Subject: Addendum 1 for: Replace Bridge 134 over Old Toms Creek Tributary 1

Contract No.: DM00183
WBS Element: 17BP.13.R.54
Route: SR 1433
County: McDowell

STATE OF NORTH CAROLINA
 DEPARTMENT OF TRANSPORTATION
 RALEIGH
 30' X 3' PRECAST
 REINFORCED CONCRETE
 THREE-SIDED CULVERT
 ON SR 1433 AT
 TOMS CREEK TRIBUTARY
 JANUARY 2013

NO.	BY:	DATE:	NO.	BY:	DATE:	SHEET NO.
1	SDC	8/16	3			S-1
2			4			TOTAL SHEETS 2

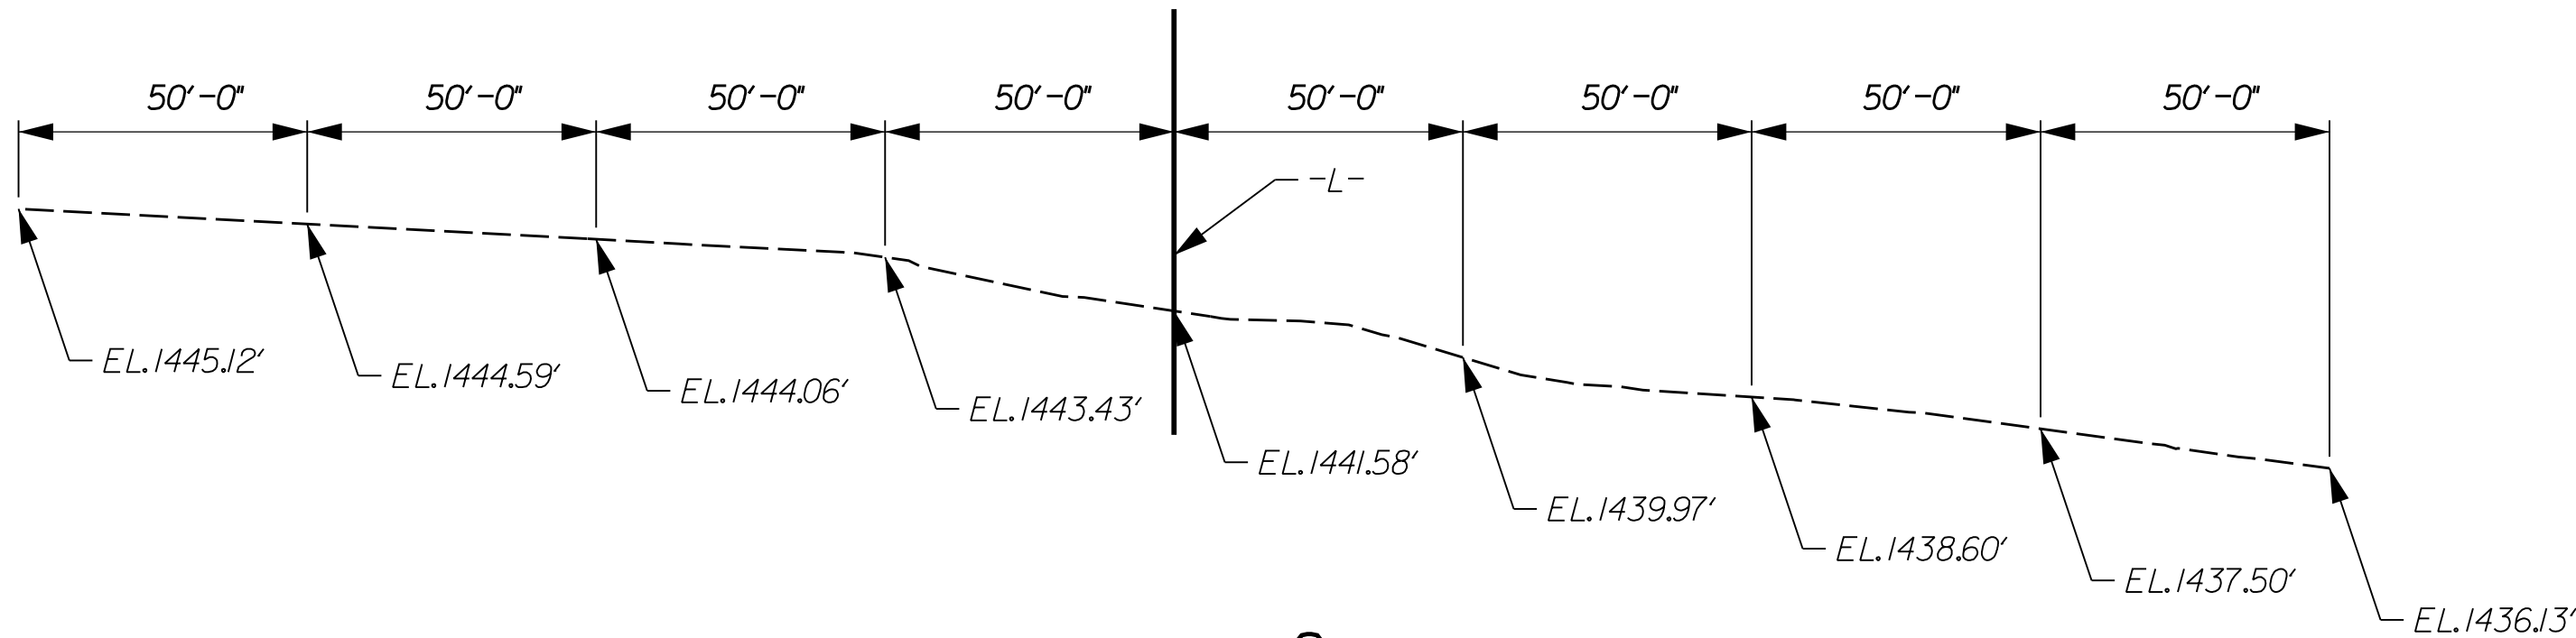
- Plan sheet S-1 has been revised to show the culvert length. Please use this revised plan sheet for bidding and construction purposes.
- Please note receipt of this addendum on page 120 of the contract proposal

REVISD TO INCLUDE CULVERT LENGTH
